Access Compliance Report

Public Rights-of-Way

Intersection ID: 50233	Main Street: ORCHARD_STONE_RN	Cross Street: ARDREY_KELL_RD	Location: NE
ADA ID: 7DEE6F485C88	Ramp Type: Perp	Initial Pass/Fail: Pass	Overall Compliance: No
		Severity Score: 5

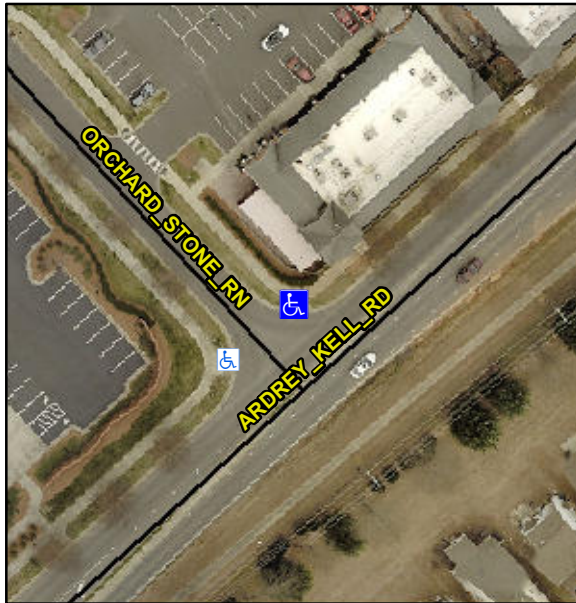
Compliance	Description	Data	Compliance	Description	Data
N/A	Ramp Length (in)	61.5	Yes	Ramp Slope (%)	7.3
Yes	Ramp Width (in)	48.0	Yes	Ramp XSlope (%)	1.3
N/A	Flare Type LT	Sloped	N/A	Flare Type RT	N/A
N/A	Flare Slope LT (%)	3.6	No	Flare Slope RT (%)	13.0
N/A	Flare Traversable LT?	Yes	N/A	Flare Traversable RT?	Yes
Yes	Landing Length (in)	69.0	Yes	DWS Provided?	Yes
Yes	Landing Width (in)	48.0	Yes	DWS Contrast?	Yes
No	Landing Slope (%)	3.0	Yes	DWS Length (in)	24.5
Yes	Landing X Slope (%)	1.6	Yes	DWS Full Width?	Yes
N/A	Landing Curb? (Y/N)	No	Yes	DWS Offset (in)	1.0
N/A	Shared Landing?	No			
Yes	Gutter Ponding?	No	Yes	Gutter Slope (%)	3.6
Yes	Gutter Lip Ht (in)	0.0	Yes	Gutter X Slope (%)	1.1
N/A	Painted X Walk1?	No	N/A	Painted X Walk2?	N/A
	X Walk 1 Direction	To SW		X Walk 2 Direction	N/A
N/A	X Walk 1 Width (in)	N/A	N/A	X Walk 2 Width (in)	N/A
	X Walk 1 Slope (%)	0.6		X Walk 2 Slope (%)	N/A
	X Walk 1 X Slope (%)	2.4		X Walk 2 X Slope (%)	N/A

Remove & Replace Entire Ramp.
